UNITED STATES PATENT AND TRADEMARK OFFICE

Office Action Summary	Application No. 10/564,433	Applicant(s) CLASSEN ET AL.	
	Examiner FRANKIE L. STINSON	Art Unit 1792

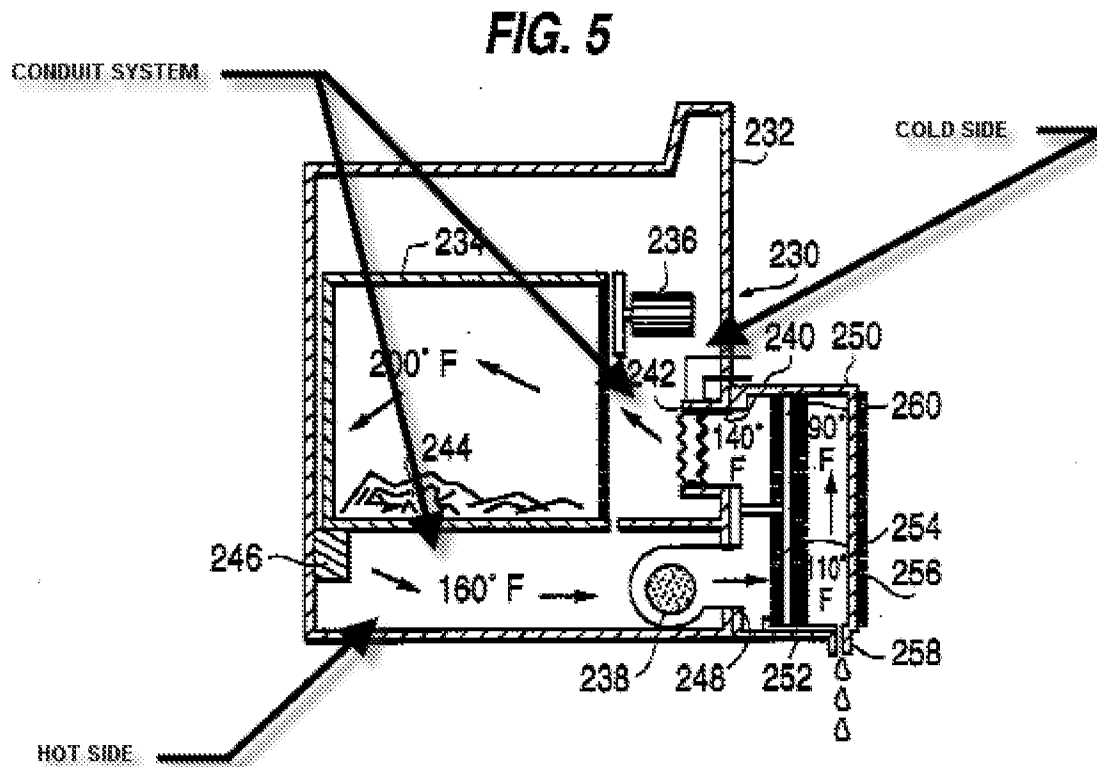
6. Claims 10-18 are rejected under 35 U.S.C. 103(a) as being unpatentable over Dinh (U. S. Pat. No. 5,343,632) in view of France'322 (France 2 491 322) and Moratalla (U. S. Pat. No. 5,732,562).

Re claim 10, the patent to Dinh is cited disclosing a dishwasher (col. 8, lines 9-10) comprising:

a washing basket (see France'322, for corresponding dishwasher limitations); and
a conduit system (see annotated fig. 5 below) connected to the washing basket in an air-guiding manner such that air is guided from the washing basket to the conduit system and air is guided from the conduit system to the washing basket and the conduit system including a cold side portion and a hot side portion, the conduit system being operable to guide air from the washing basket through the cold side portion, to promote
